Peach Bottom Atomic Power Station, Units 2 and 3
Renewed Facility Operating License Nos. DPR-44 and DPR-56
NRC Docket Nos. 50-277 and 50-278

Subject: First Six-Month Status Report in Response to March 12, 2012 Commission Order
Modifying Licenses with Regard to Requirements for Mitigation Strategies for Beyond-
Design-Basis External Events (Order Number EA-12-049)

**First Six-Month Status Report for the Implementation of Order EA-12-049, Order
Modifying Licenses with Regard to Requirements for Mitigation Strategies for Beyond-
Design-Basis External Events**

PBAPS Primary and Alt Power Requirements

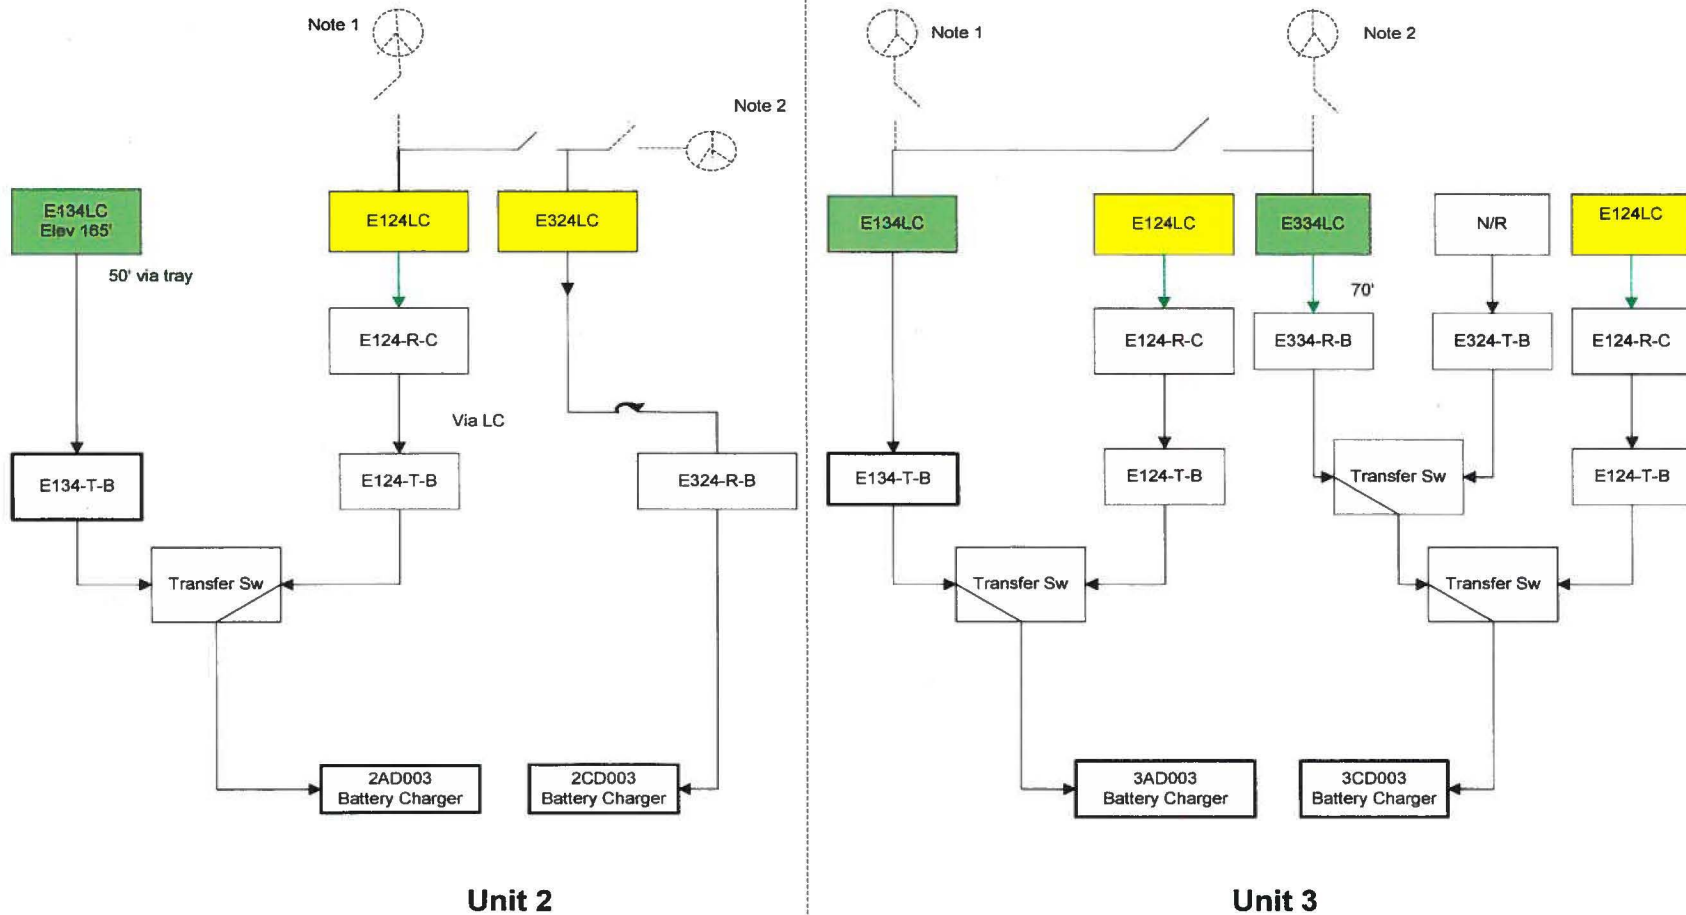
Attachment 1 Conceptual Sketch and the discussion section for Safety Function Support show modifications to install FLEX 480VAC generator connections. The primary strategy is being revised to install a 480VAC portable generator connection in each unit's 135' elevation reactor building railroad access bay with cable supplying transfer switches to the E124 and E134 Load Centers. The alternate

strategy is being revised to install a 480VAC portable generator connection at each unit's Outage Power area behind the Reactor Building on the west wall with cable supplying the E324 and E334 Load Centers. Existing cabling between the E124 and E324, and the E134 and the E334 Load Centers will be used to crosstie power from the FLEX generators. The 480VAC motor control centers required for FLEX will be powered from the E124, E324, E134 and E334 Load Centers. No new cables or modifications will be required to the motor control centers.

This change reduces the number of 480VAC Load Centers and Motor Control Centers to be powered by the FLEX generators. On Unit 2 the E224 and E424 480VAC Load Centers and the E224-R-B and E424-T-B 480VAC Motor Control Centers will not be powered. On Unit 3 the E234 480VAC Load Center and the E234-R-B and E234-T-B Motor Control Centers will not be powered. The Division 2 "B" RHR MO-2(3)-25B valve for vessel injection and the MO-2(3)-39B and MO-2(3)-34B valves for Torus makeup will not have power and will be unavailable for operation from the Control Room. The Division 2 "B" RHR MO-2(3)-25B valve for vessel injection and the MO-2(3)-39B and MO-2(3)-34B valves for Torus makeup are not required for compliance with Order EA-12-049.

The OAV030 Control Room Emergency Vent Supply Fan A, the OAV034 Emergency Switchgear and Battery Room Vent Supply Fan A and the OAV036 Battery Room Exhaust Fan A are powered from the E324-T-B Motor Control Center and will be available for operation.

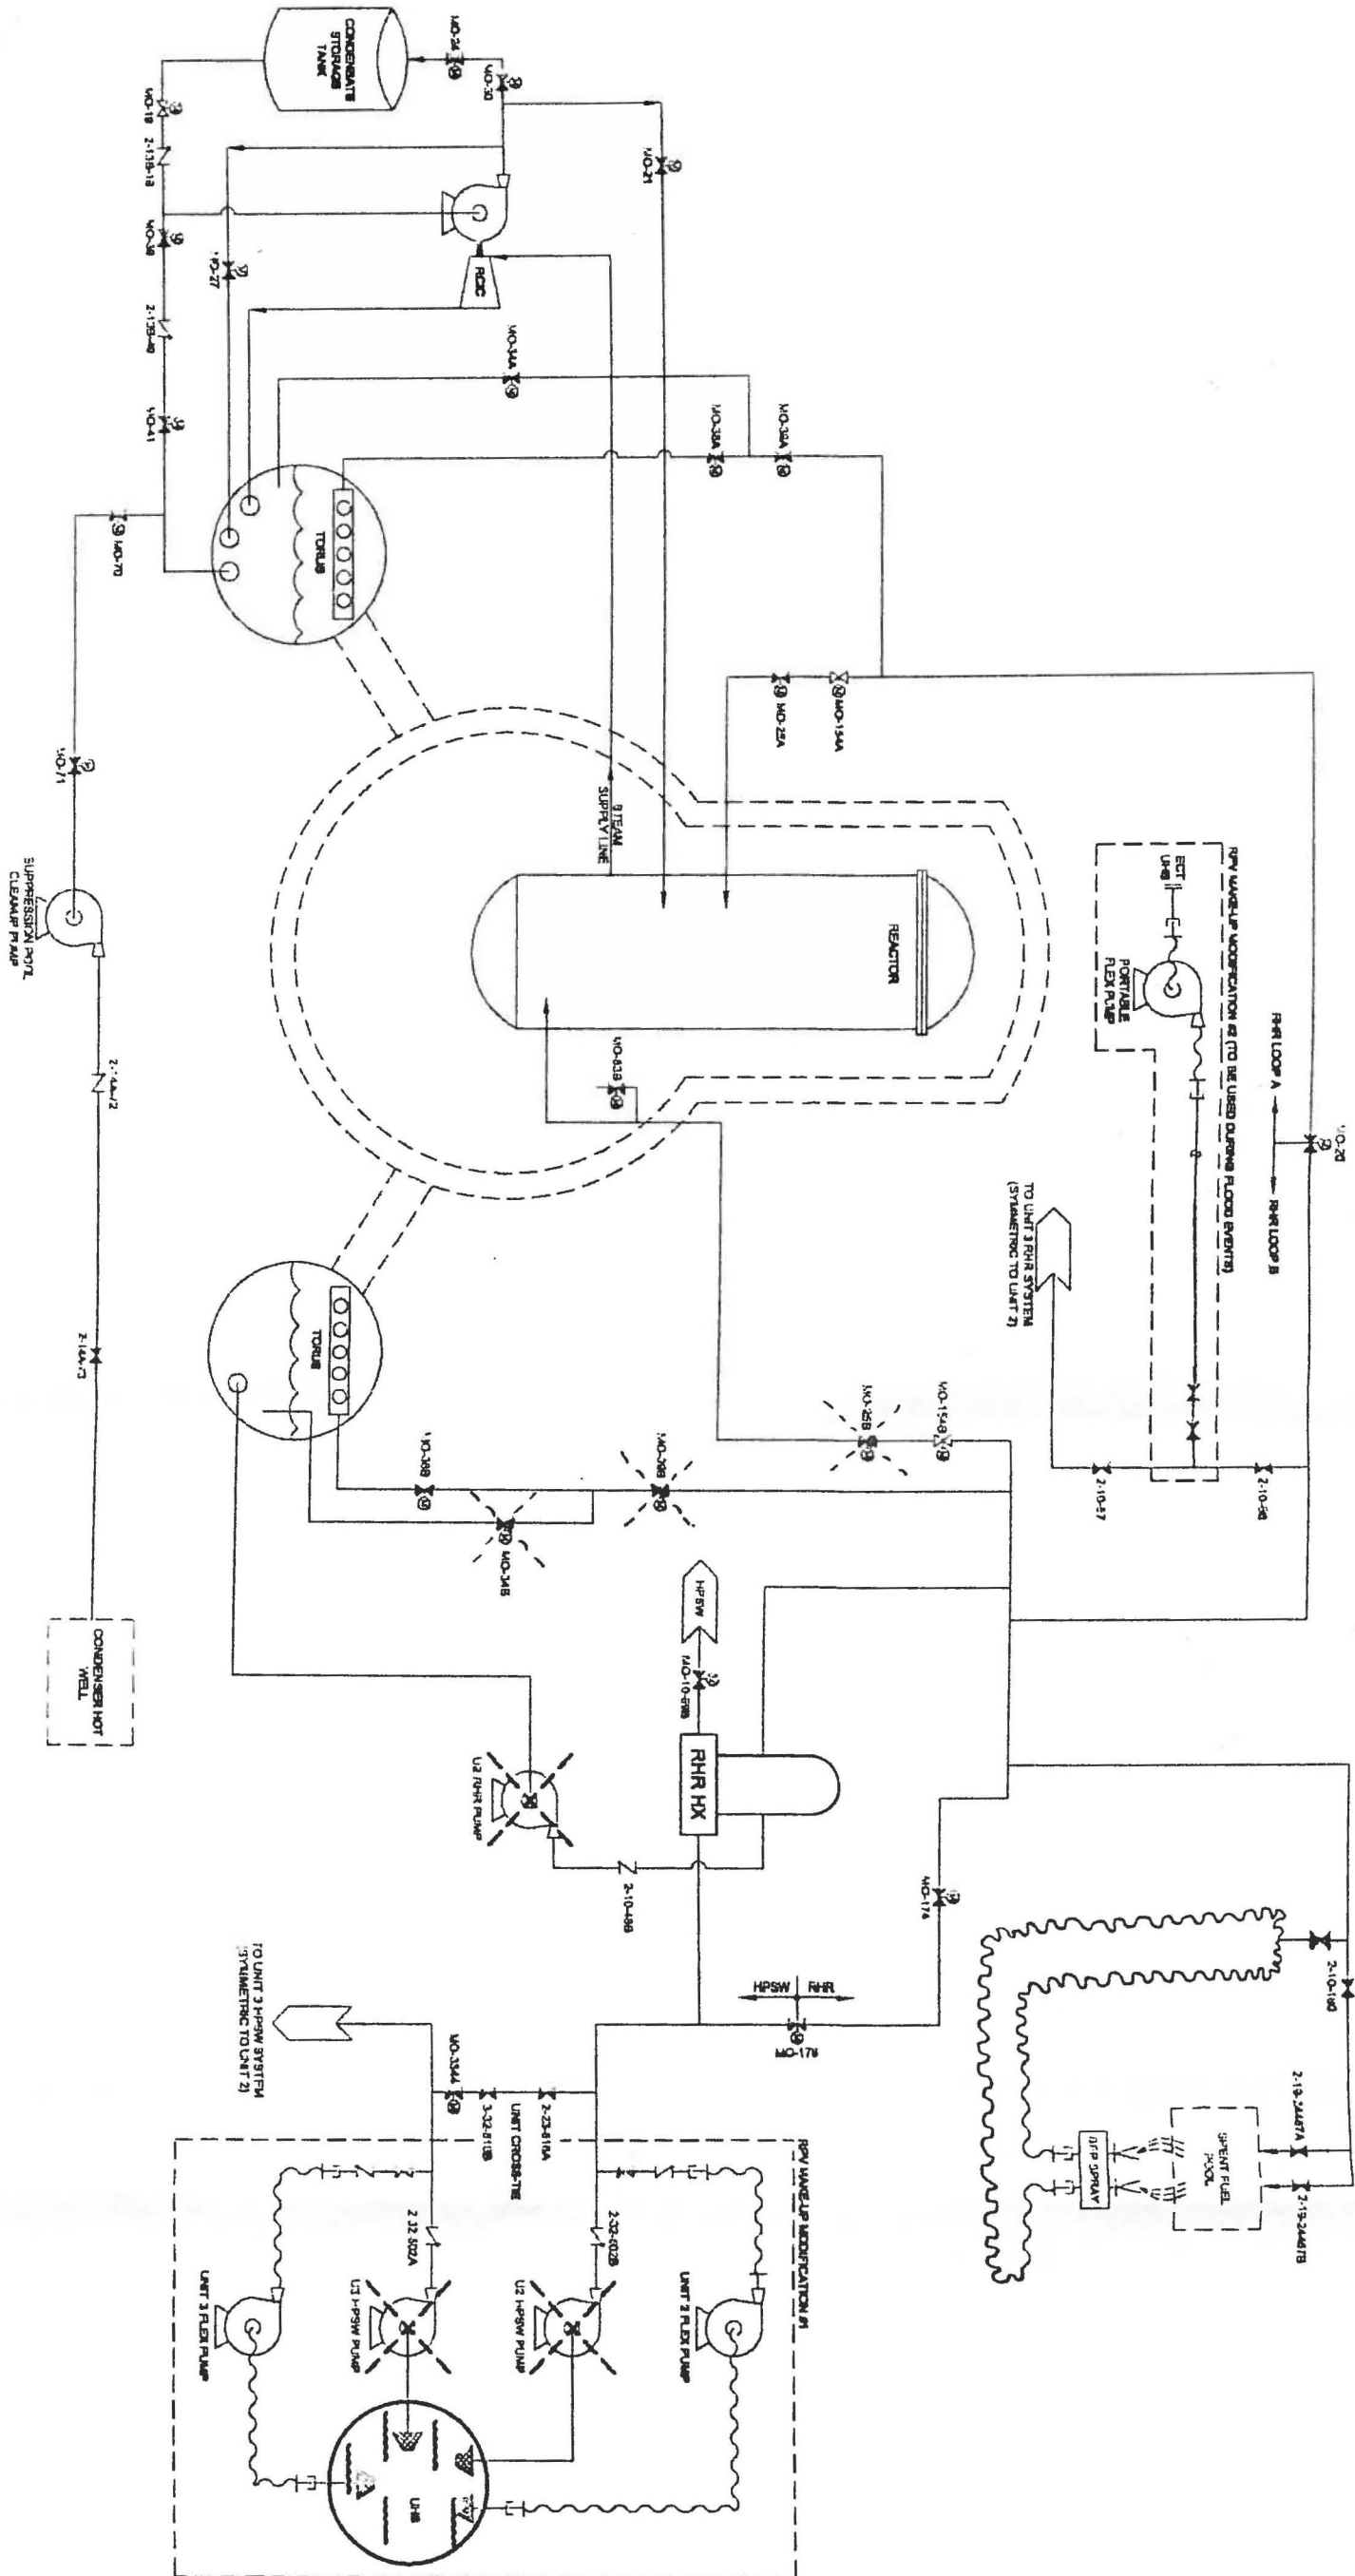
Attachment 2 Conceptual Sketch and the SFP Makeup discussion section for the Maintain Spent Fuel Pool Cooling show water supply modifications to the Spent Fuel Pool by installing additional manual valves and hose connections downstream of HV-(3)-4457A and HV-2(3)-4457B. This is being revised to a single hose connection upstream of the HV-2(3)-4457A and HV-2(3)-4457B on 165' Reactor Building with sections of fire hose then routed to the 234' elevation of the Refuel Floor. Hoses will then be used to makeup to the Spent Fuel Pool or provide spray capability to the Spent Fuel Pool. The new hose connections will be installed on seismically rated piping.
